RE: License No. SUA-1228 (Nine Mile Lake); Amendment Request of March 31, 1980

Pursuant to our telephone conversation of May 28, 1980, this letter is being sent to correct the oversights and ommissions in the Amendment Request referenced above.

FIGURE I
CARBONATE PROCESS, ABSORPTION & ELUTION

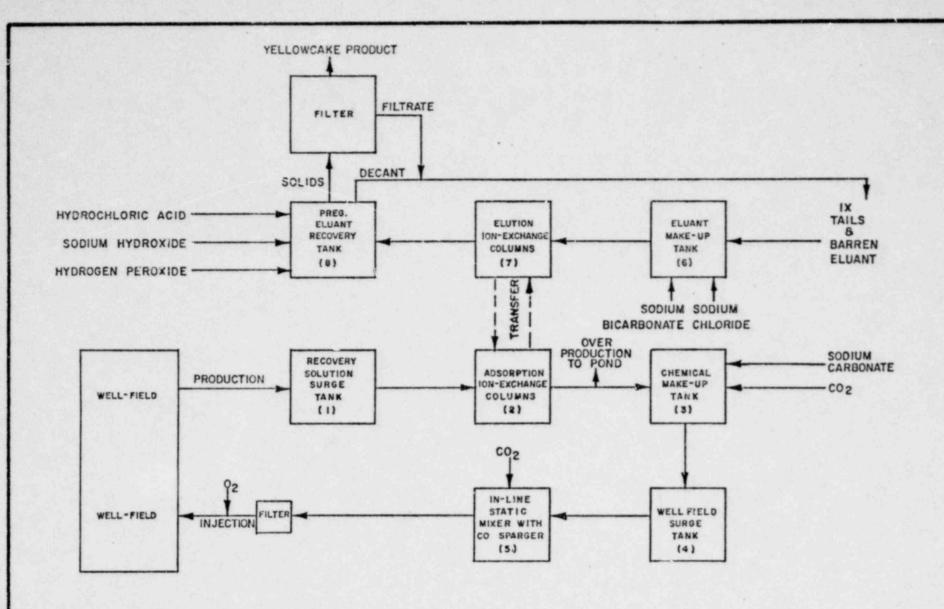
As you assumed, RMEC does intend to use an oxidant with the carbonate lixiviant. Initially, hydrogen peroxide will be added to the lixiviant at a rate of about 0.5 g/l prior to reinjection into the wellfield. Oxygen will also be tested as an oxidant. Attachment A (Figure 1) shows oxidant addition following the filtration step prior to reinjection.
